Barrick Gold Inc.

March 31, 2005

Reference: F-90132

***2004 Tailings Dam Examination
Cullaton Lake Gold Mine, Nunavut
Licence NWB1CUL020***

Photo 6: Dam No. 1 Spillway Channel looking downstream to Pond 2

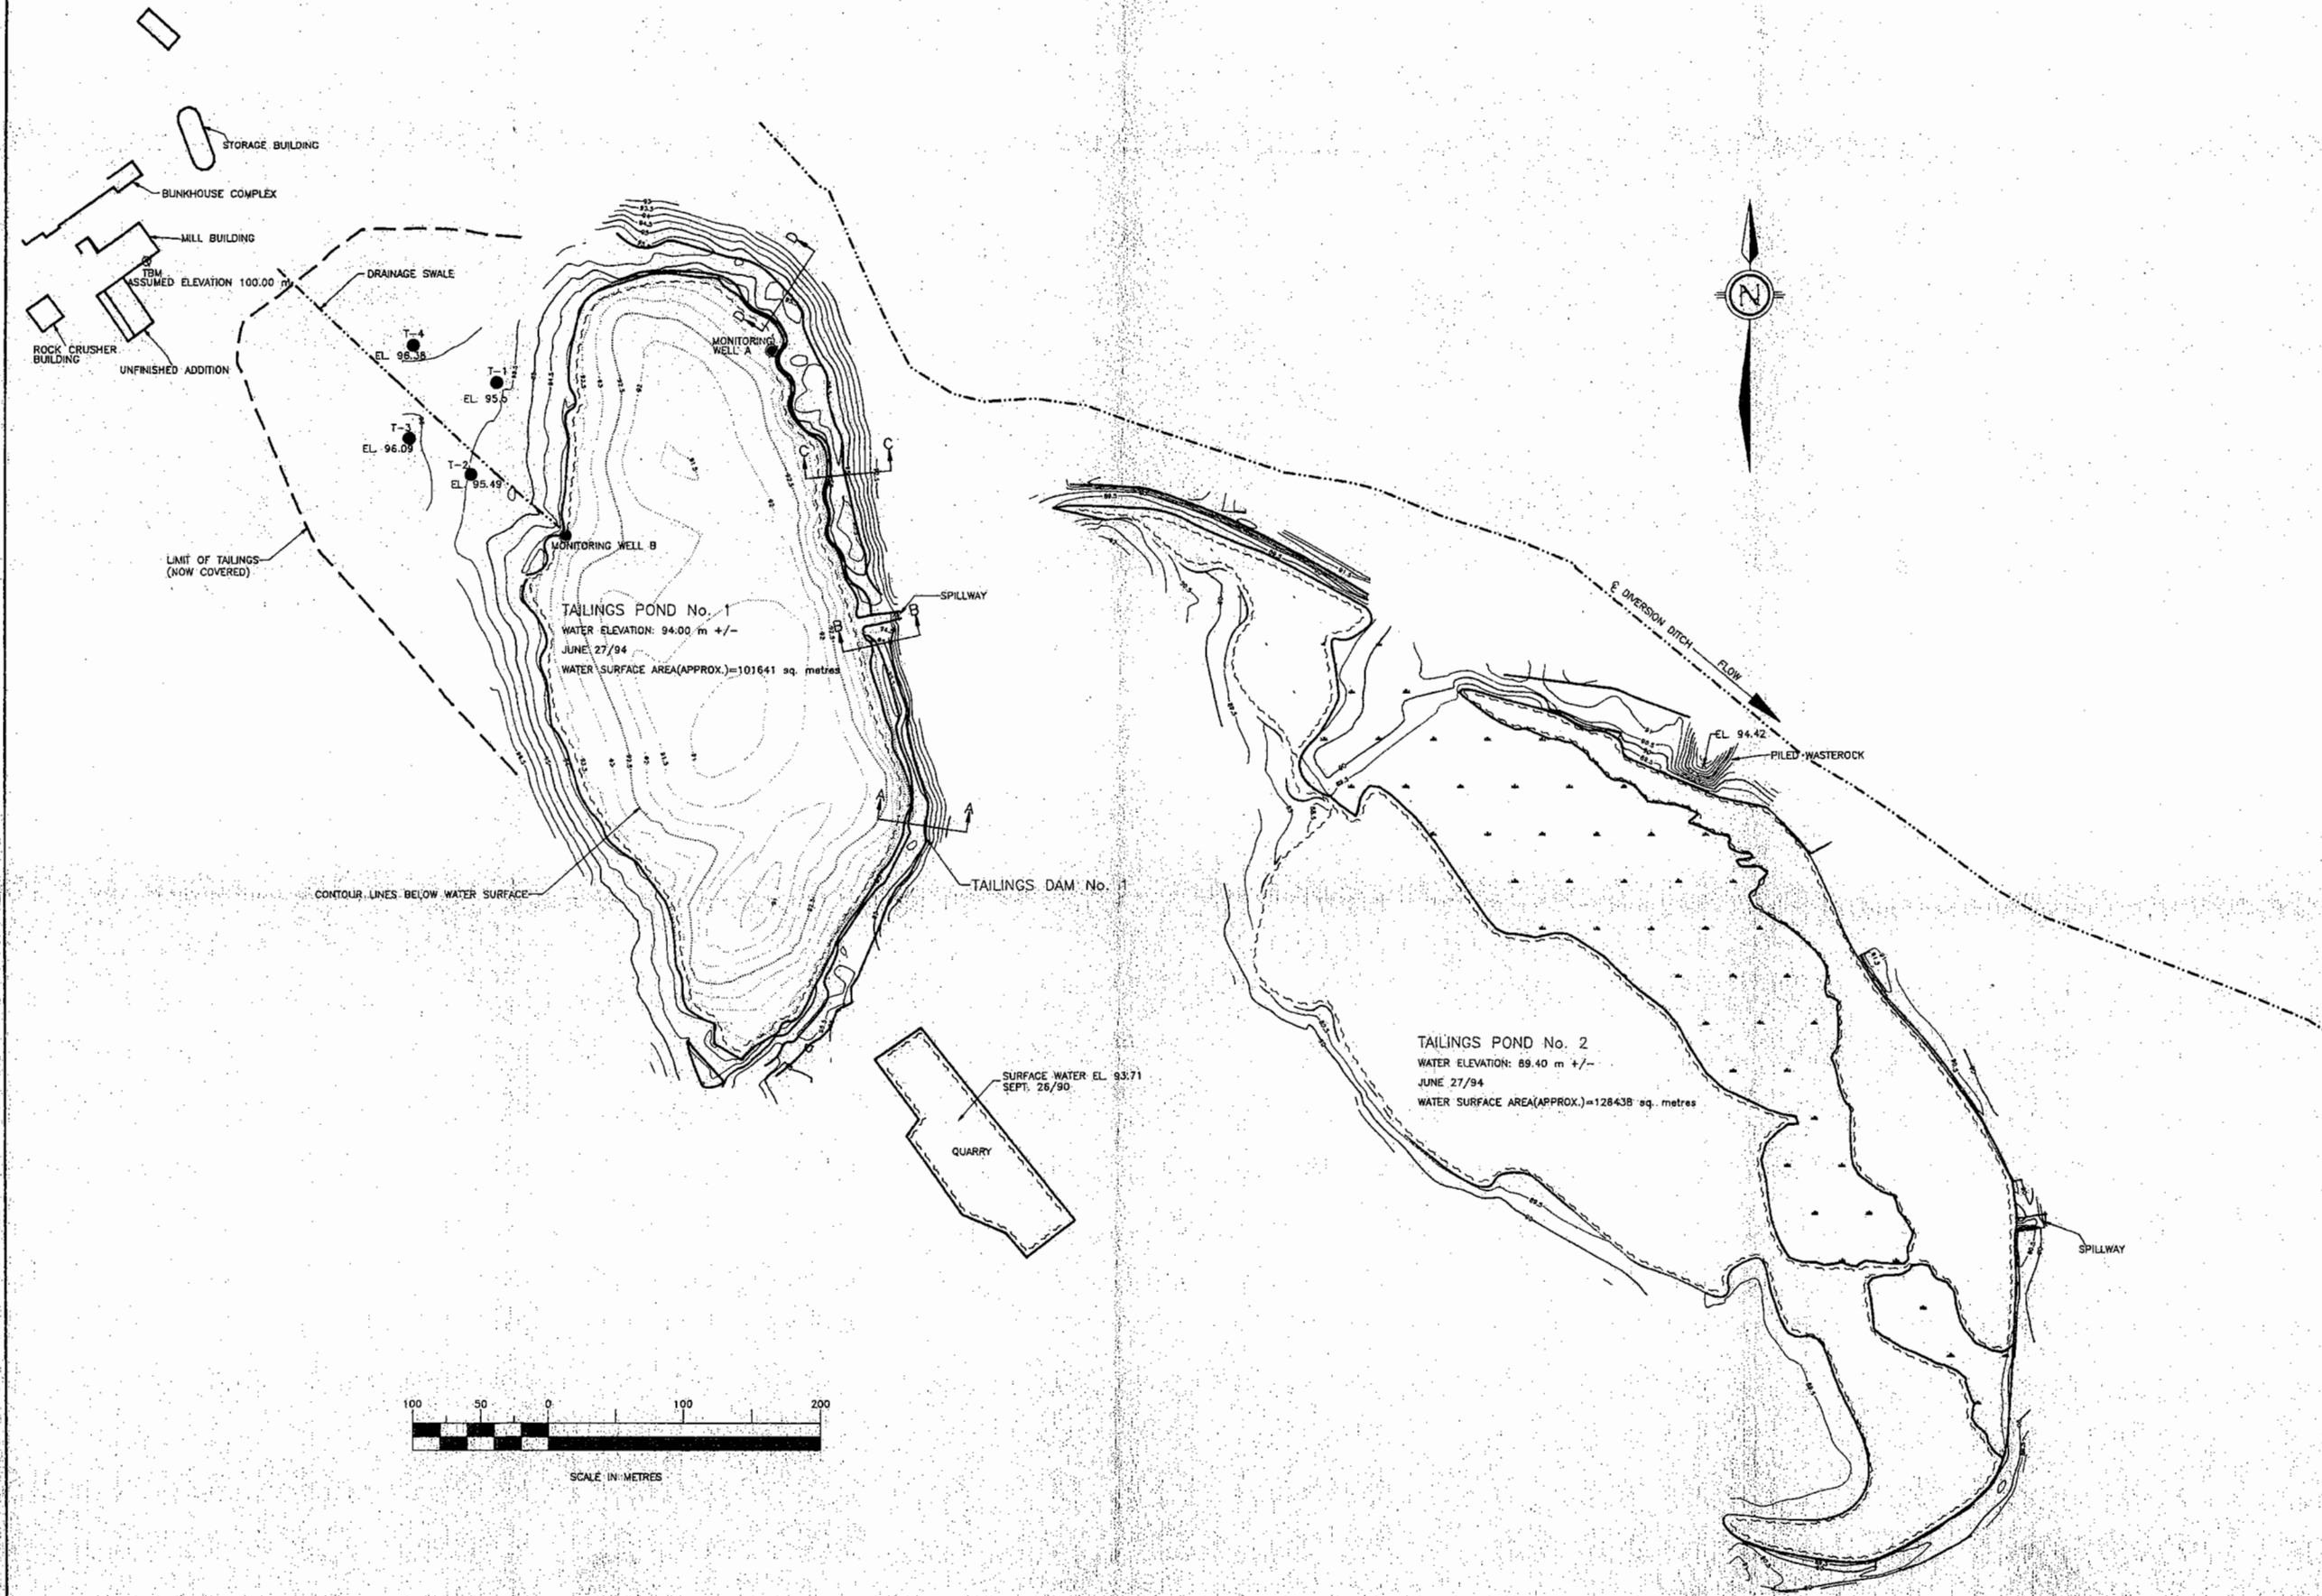
Photo 6 shows a view of the spillway channel. The Pond No. 1 level was estimated to be at an elevation of about 94.0 m, approximately at the spillway crest level and minor flow was occurring over the spillway, as can be seen in Photo 6. This is approximately the same water level that was observed in the 1994, 1996 and 2001 examinations when the levels were at about 94.0 m, and slightly higher than the 93.7 m estimated in 1999. The difference in water levels is likely due to natural seasonal hydrologic variations, including precipitation, infiltration, runoff and evaporation.

Portions of the rubber liner in the spillway channel were exposed, as they were in 1996. No repairs were made subsequent to the recommendation of 1996. We have not observed any change in the configuration since this was identified. However, at issue is the potential for the liner to degrade and expose the underlying cohesionless subsoil. This could conceivably subject the channel base to erosion during periods of high runoff, ultimately creating an erosion channel which would lower the nominal pond level, thereby exposing the tailings. At worst, an erosion breach could occur, resulting in the loss of tailings into Pond 2. Accordingly, it is considered prudent to restore the design configuration of the spillway channel.

It is recommended that the rubber liner in the Dam 1 spillway be repaired and restored to its original design configuration, to ensure that it is recovered with the appropriate rip-rap, such that erosion of the subbase does not occur.
